Form 3160-5
(June 2019)

SUNDRY NOTICES AND REPORTS ON WELLS
Do not use this form for proposals to drill or to re-enter an abandoned well. Use Form 3160-3 (APD) for such proposals.

Betty 5 Fed Com 221H (FKA Getty 5 Fed Com 755H) API #: 30-025-52102

EOG respectfully requests an amendment to our approved APD for this well to reflect the following changes:

WELL LOCATION AND ACREAGE DEDICATION PLAT

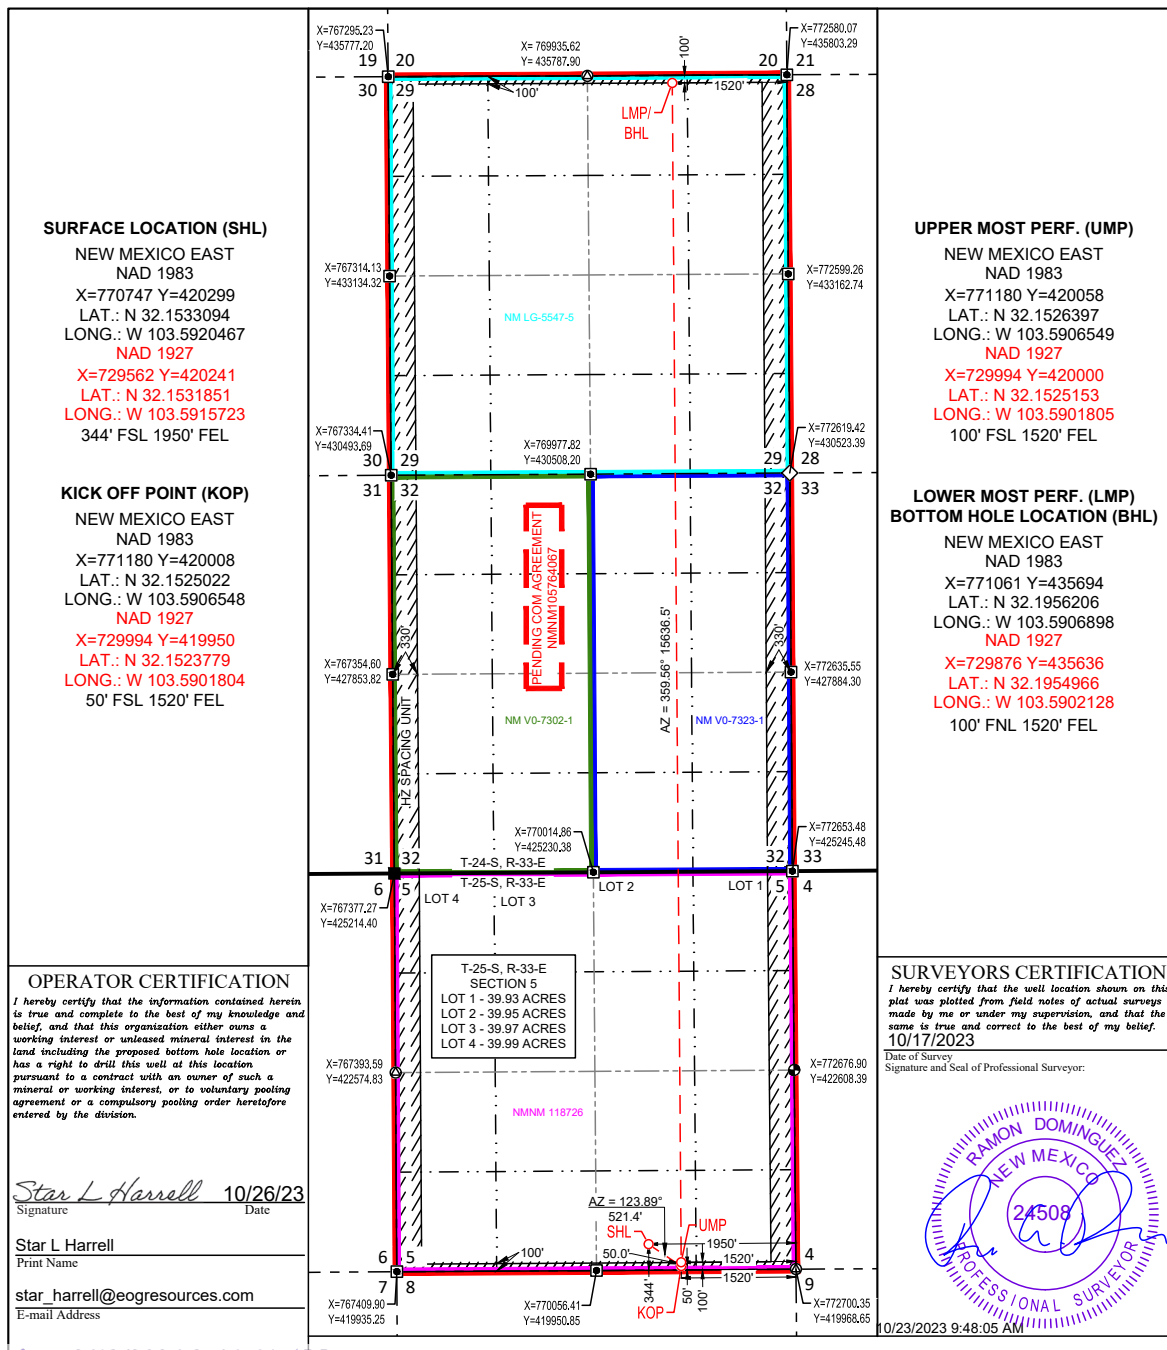
Change name from Getty 5 Fed Com 755H to Betty 5 Fed Com 221H.

Change SHL from T-24-S, R-33-E, Sec 5, 1313' FSL, 1593' FWL, Lea Co., NM, to T-25-S, R-33-E, Sec 5, 344' FSL, 1950' FEL, Lea Co., N.M.

Change BHL from T-24-S, R-33-E, Sec 32, 2593' FSL, 1871' FWL, Lea Co., NM, to T-24-S, R-33-E, Sec 29, 100' FNL, 1520' FEL, Lea Co., N.M.

UL or lot no.	Section	Township	Range	Lot Idn	Feet from the	North/South line	Feet from the	East/West line	County
O	5	25-S	33-E	-	344'	SOUTH	1950'	EAST	LEA

UL or lot no.	Section	Township	Range	Lot Idn	Feet from the	North/South line	Feet from the	East/West line	County
B	29	24-S	33-E	-	100'	NORTH	1520'	EAST	LEA

Design A

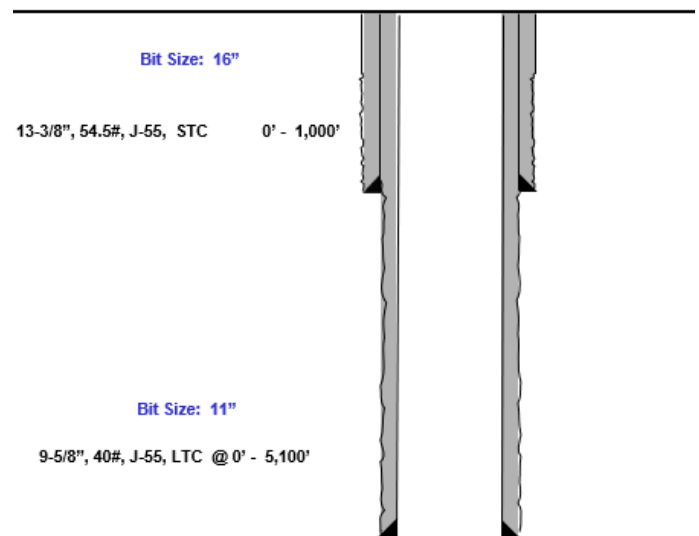
EOG request permission to allow deviation from the 0.422" annulus clearance requirement for the intermediate (salt) section from Onshore Order #2 under the following conditions:

- The variance is not applicable within the Potash Boundaries or Capitan Reef areas.
- Operator takes responsibility to get casing to set point in the event that the clearance causes stuck pipe issues

Proposed 11" Hole with 9.625" 40# J55/HCK55 LTC Casing

- 11" Bit + 0.52" Average hole enlargement = 11.52" Hole Size
 - 0.9475" Clearance to casing OD

$$= \frac{11.52 - 9.625}{2}$$
 - 0.4475" Clearance to coupling OD

$$= \frac{11.52 - 10.625}{2}$$
- Previous Shoe – 13.375" 54.5# J55 STC
 - 0.995" Clearance to coupling OD (~1,200' overlap)

$$= \frac{12.615 - 10.625}{2}$$

**Break-test BOP & Offline Cementing:**

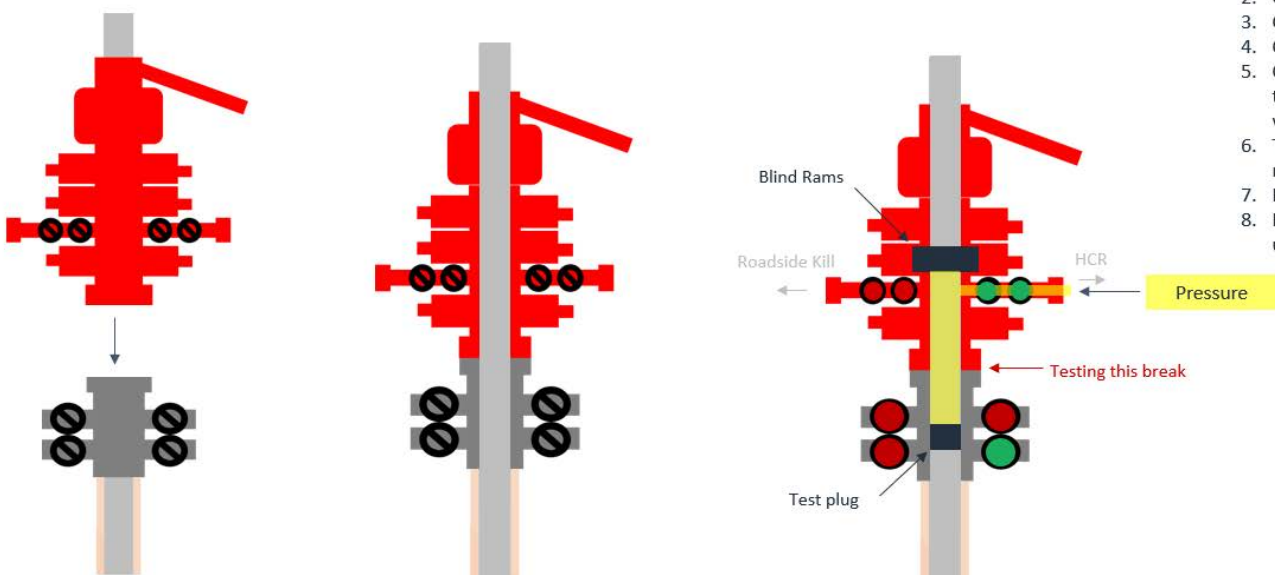
EOG Resources Inc. (EOG) respectfully requests a variance from the minimum standards for well control equipment testing of ECFR Title 43 Part 3172.6(b)(9)(iv) to allow a testing schedule of the blow out preventer (BOP) and blow out prevention equipment (BOPE) along with Batch Drilling & Offline cement operations to include the following:

- Full BOPE test at first installation on the pad.
- Full BOPE test every 21 days.
- This test will be conducted for 5M rated hole intervals only.
- Each rig requesting the break-test variance is capable of picking up the BOP without damaging components using winches, following API Standard 53, Well Control Equipment Systems for Drilling Wells (Fifth edition, December 2018, Annex C. Table C.4) which recognizes break testing as an acceptable practice.
